REFERENCE:	TSB: 08-130-23 GROUP 08 - Electrical	Date:	May 26, 2023	REVISION:	—
VEHICLES AFFECTED:	2022 (DS) RAM 1500 Pickup 2022 (DJ) RAM 2500 Pickup 2022 (D2) RAM 3500 Pickup 2022 (DD) RAM 3500 Cab Chassis 2022 (DF) RAM 3500 10K LB. Cab Chassis 2022 (DP) RAM 4500/5500 Cab Chassis This bulletin applies to vehicles equipped with Global Telematics Box Module (Sales Code RDG).			MARKET APPLICABILITY:	
				<input checked="" type="checkbox"/> NA	<input type="checkbox"/> MEA
				<input type="checkbox"/> SA	<input type="checkbox"/> IAP
				<input type="checkbox"/> EE	<input type="checkbox"/> CH
CUSTOMER SYMPTOM:	Customers may experience one or more of the following: <ul style="list-style-type: none"> • Uconnect Box Message at Startup. • Uconnect Box Error Or Requires Service Message. • Connectivity: Uconnect Mobile App trunk status showing as closed when trunk is open. • Connectivity: Diagnostic Trouble Codes (DTCs) for Electronic Control Modules (ECUs) won't be shown to customer through the Vehicle Health alert (Mobile app or email).

CAUSE:	TBM Software

Fig. 1
Uconnect Box Error Message

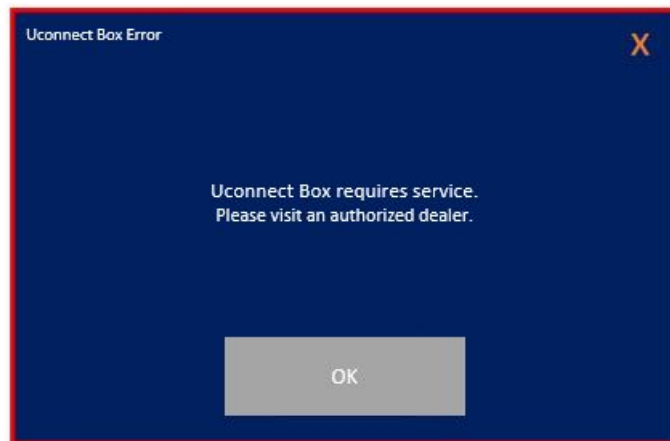
Message display on the radio screen, “Uconnect Box requires service. Please visit an authorized dealer.” (Fig. 1) , with no active or stored DTCs set by the TBM.

This bulletin provides information regarding the latest Firmware Over The Air (FOTA) update and provides the service technician an overview of the steps a customer will need to take to complete the update. The TBM software will be updated from 5.13 to 5.25 to 5.39.1 (DS) and 5.25 to 5.39.1 (DJ, DD, D2, DP, DF).
